# Technical Service Bulletin

RMI-TSB-001-20170701

## NEW Dual Blower Control Module Kits For ALL APU's With Dual Blowers

KL7-023

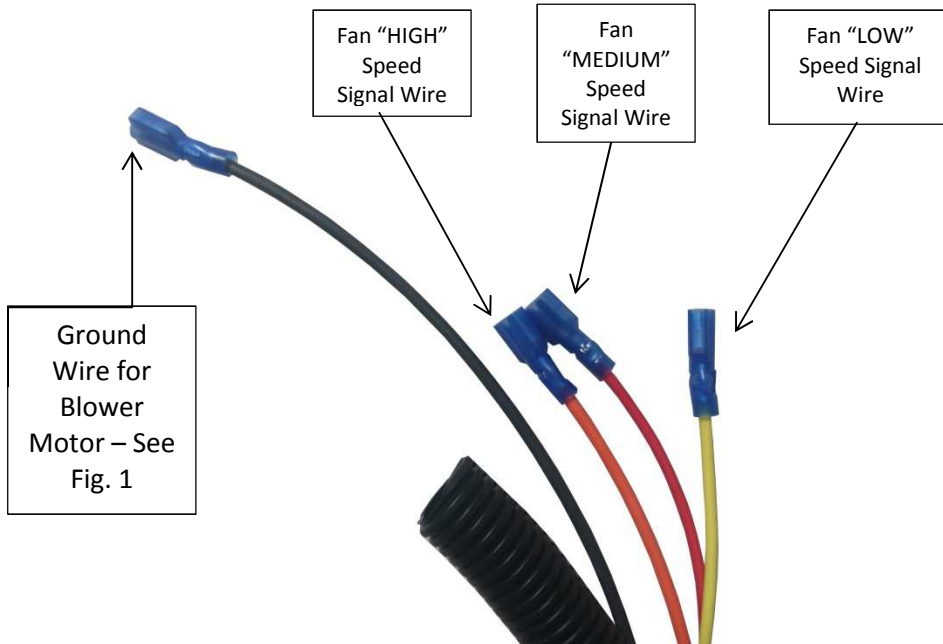
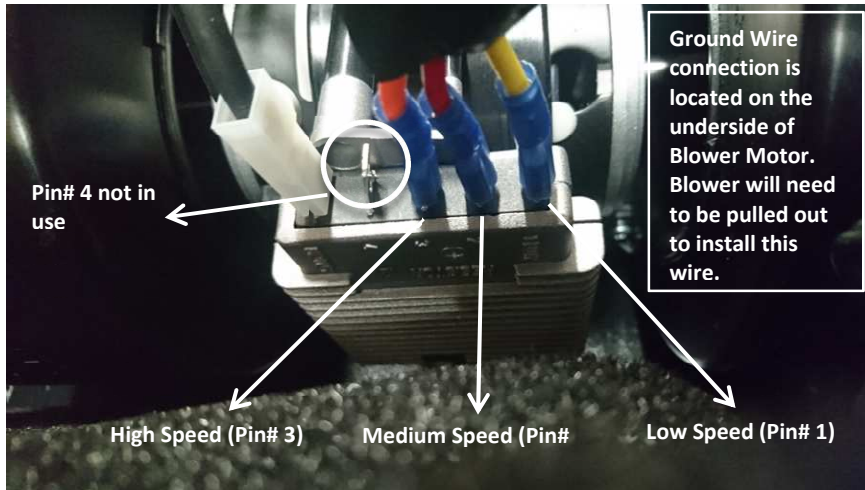
#### Changes made to Dual Blower Control Module.

- No fixed wiring harness
- Fuse built in to Module

KL7-023-01

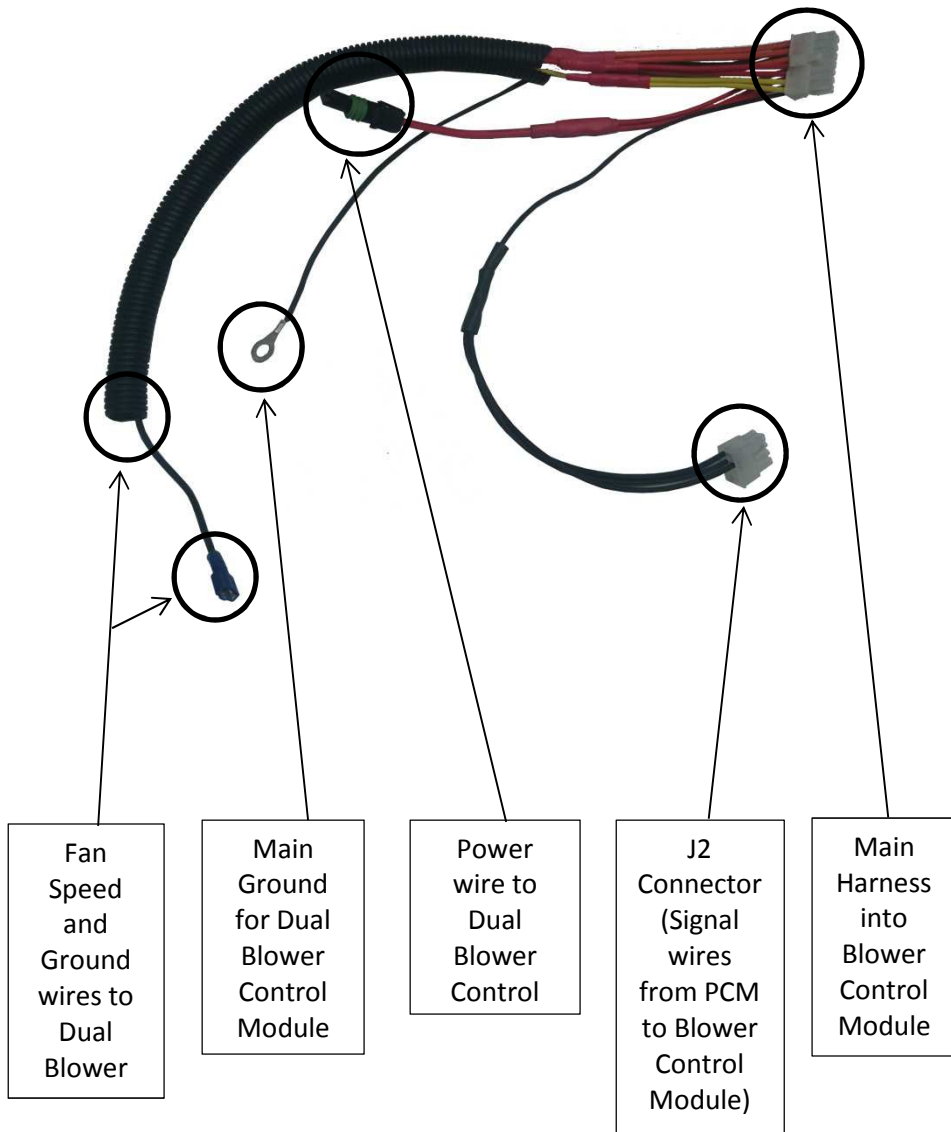
This wiring harness will replace the pre-existing harness that was attached to the previous version of the **Dual Blower Control Module**. Once this harness has been installed it will be fixed to the HVAC Box and will **ONLY** need to be replaced if there is any type of damage to the harness itself.
